## STAFF REPORT

**Project:** #2026-COA-225  
**Address:** 2724 Arapahoe Street  
**Historic District:** Curtis Park 'F' Historic District  
**Year structure built:** c. 1884 (Period of Significance: 1870-1902)  
**Council District:** #9 - Darrell Watson  
**Applicant:** Tyler Smith & Nick Marion

Demolish Existing Addition and Construct Rear 2-Story Addition

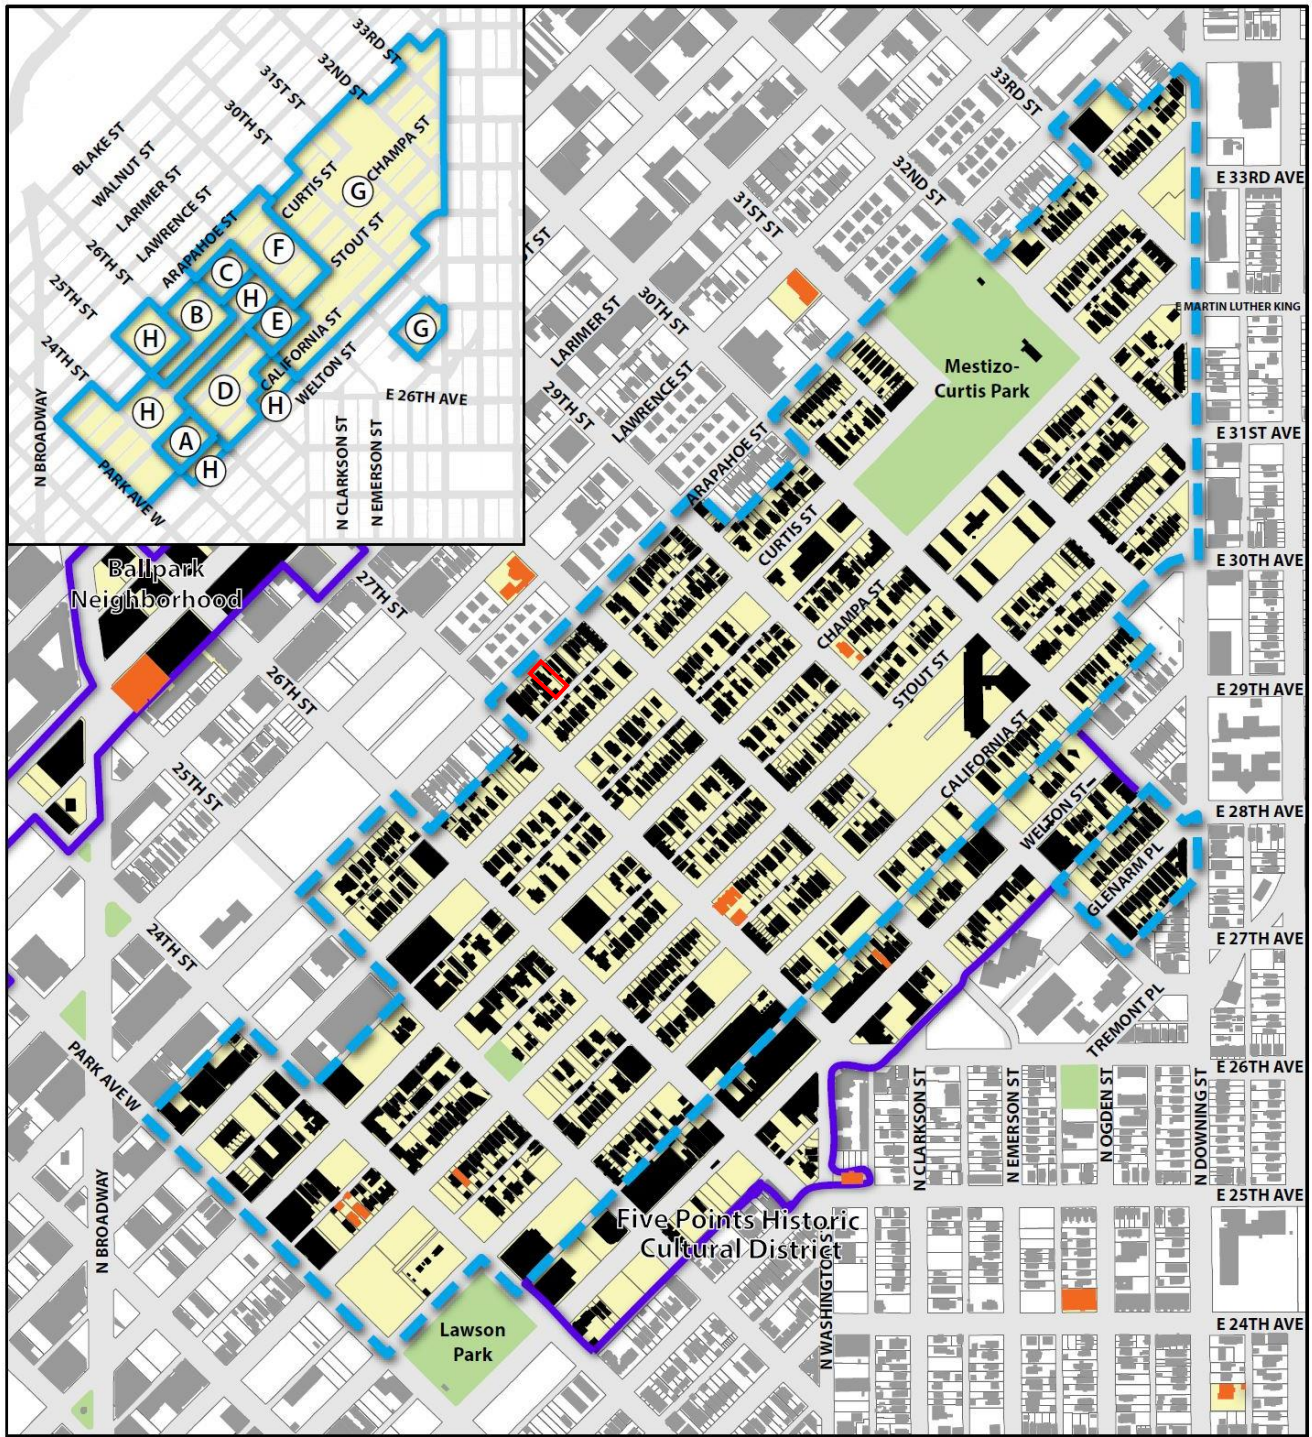
<p><b>3.2.8 Design the roof of a new addition to be compatible with the original structure and surrounding historic context.</b></p> <p>a. Use a roof form that is consistent with the original structure’s roof form and those of structures in the surrounding historic context in terms of pitch, orientation, and complexity. An addition with a pitched roof is usually inappropriate for a structure with a flat roof.</p> <p>b. If using contemporary materials, they should be compatible with historic roof materials in visual impact, texture, and relationship to architectural style.</p>	<p>Yes/No</p>	<p>Flat-roof additions have been approved in Curtis Park, and this home already includes several one-story flat-roof additions. A flat-roof addition may be appropriate where it remains subordinate in height and massing to the primary structure.</p> <p>However, the proposed addition reaches the height of the existing gable ridge, and the rooftop deck access, along with the railing/screening elements, introduces additional height and visibility.</p> <p>While a flat roof form could help mitigate the perception of additional height, the prominent and visible pitched roof forms over the enclosed stair access to the rooftop deck do not relate to the roof forms of the historic structure and instead draw attention to the addition, contrary to the intent of the guidelines.</p>
